A – Addendum #1

Wedge Creek Bridge Replacement RFP # X179-2024

Proposed Wedge Creek pedestrian bridge

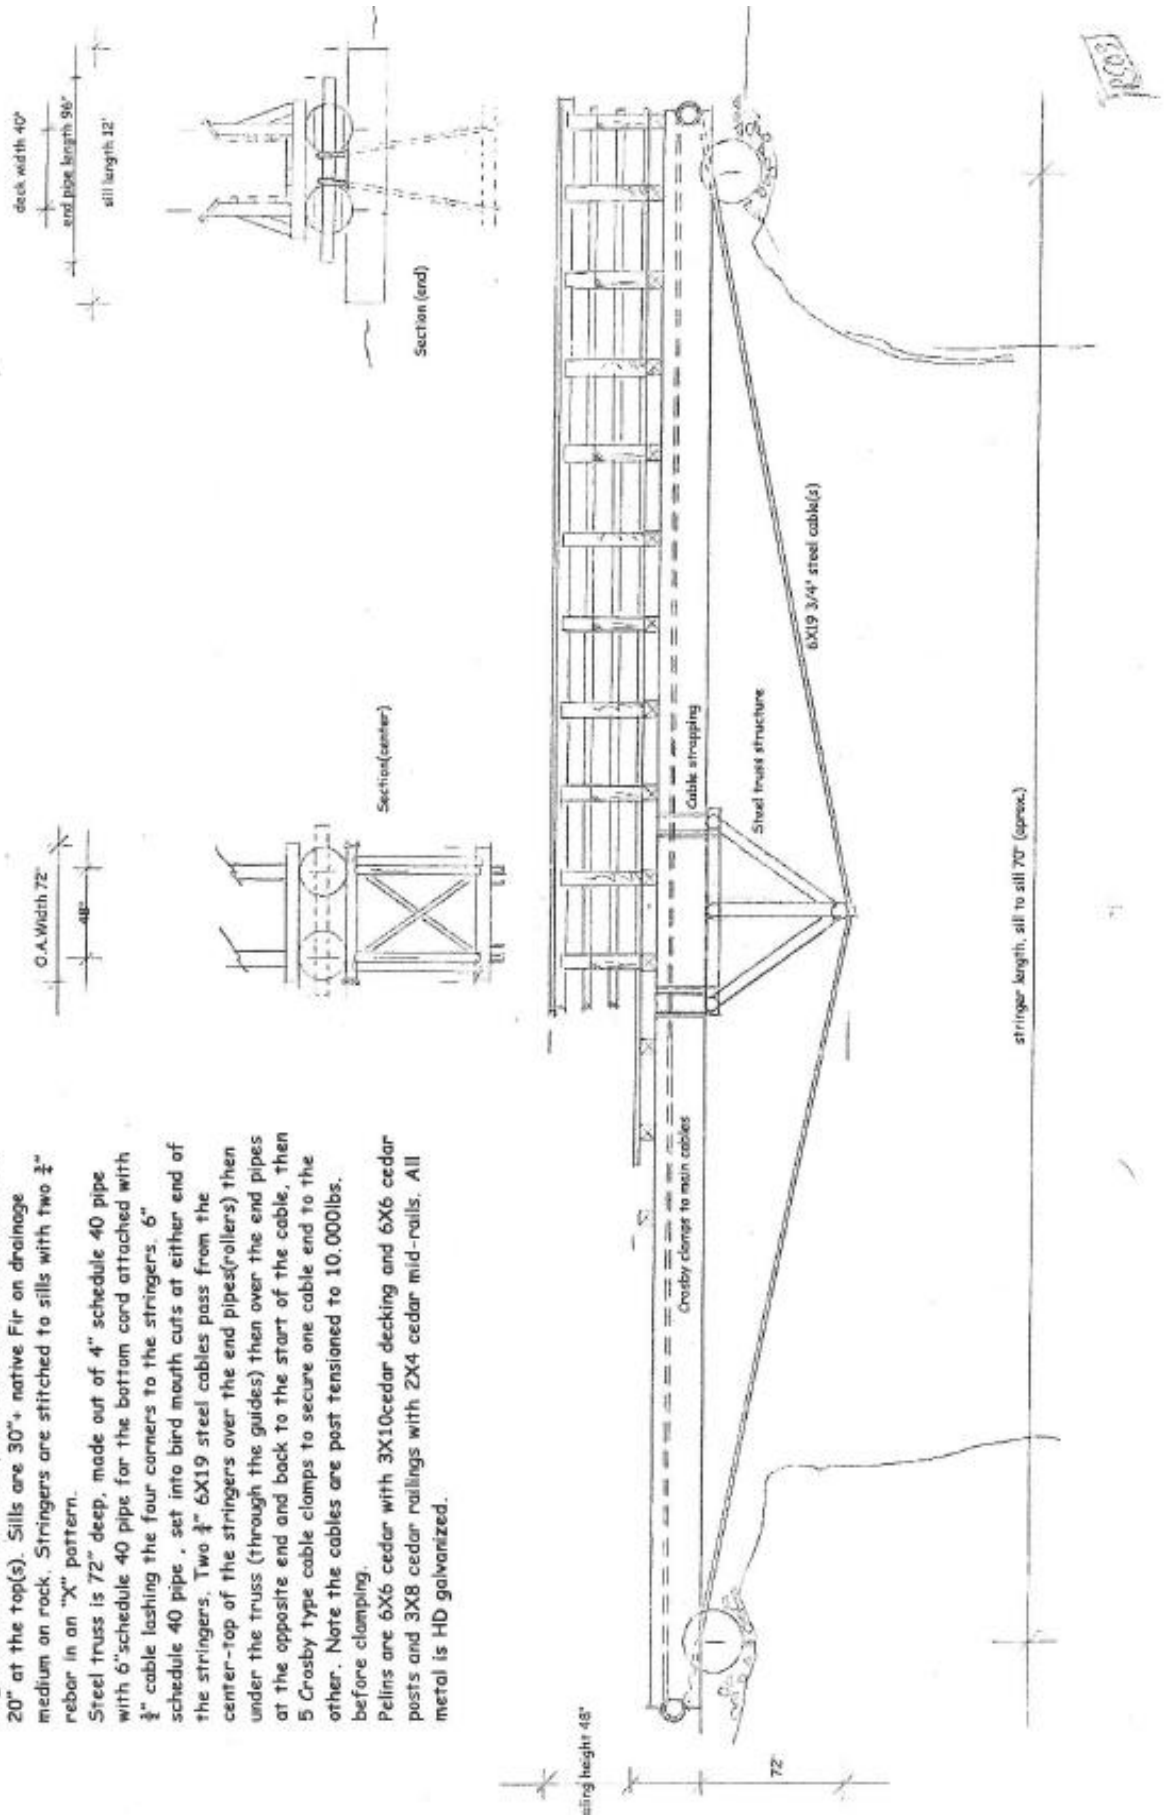
Is the original Wedge Bridge drawing available?

Drawing inserted at end of Addendum.

The Wedge creek bridge site is remote access, no roads. Native Fir bridge stringers were available, approximate length sill to sill is 72 feet, diameter is 30" at the butt to 20" at the top(s). Sills are 30"+ native Fir on drainage medium on rock. Stringers are stitched to sills with two 3/4" rebar in an "X" pattern.

Steel truss is 72" deep, made out of 4" schedule 40 pipe with 6" schedule 40 pipe for the bottom cord attached with 3/4" cable lashing the four corners to the stringers. 6" schedule 40 pipe, set into bird mouth cuts at either end of the stringers. Two 3/4" 6X19 steel cables pass from the center-top of the stringers over the end pipes(rollers) then under the truss (through the guides) then over the end pipes at the opposite end and back to the start of the cable, then 5 Crosby type cable clamps to secure one cable end to the other. Note the cables are post tensioned to 10,000lbs. before clamping.

Pellins are 6X6 cedar with 3X10 cedar decking and 6X6 cedar posts and 3X8 cedar railings with 2X4 cedar mid-rails. All metal is HD galvanized.
